Service Bulletin

BKSB-1039
Issue Date 6-16-2014

Issue: Selectable Power Setting Changes

Affected Models: KNG portable (2048 Ch.) and mobile radios upgraded from 4.6.2 to 5.1.0

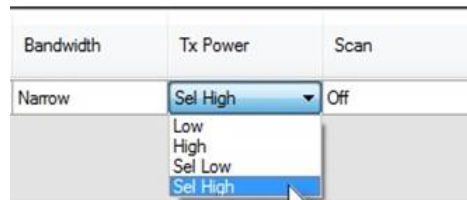
If a channel in a previous firmware version was set to **Selectable**, then updating the firmware to Ver 5.1.0 will change the setting to **Sel Low**.

In NeoVision 1.5.0 with Firmware Version 4.6.2 the Mobile Radio has three power settings Low, High and Selectable.

In NeoVision 2.0.3 with Firmware Version 5.1.0 the Mobile Radio has four power settings Low, High, Sel Low and Sel High.

Recommended Action: Change Selectable Power Setting per instructions below.

From firmware version 5.1.0 onward, the channel power may be set to any of 4 choices:

Low: The radio will always transmit at the power set in the Low Power dropdown list of the Global Conventional window.

High: The radio will always transmit at the power set in the High Power dropdown list of the Global Conventional window.

Sel Low: By default at reset, the radio will transmit at the power set in the Low Power list. However, you can switch it to High Power with a button, switch, or menu operation.

Sel High: This is the converse of **Sel Low**. By default at reset, the radio will transmit at the power set in the High Power list. Again, you can switch it to Low Power with a button, switch, or menu operation.
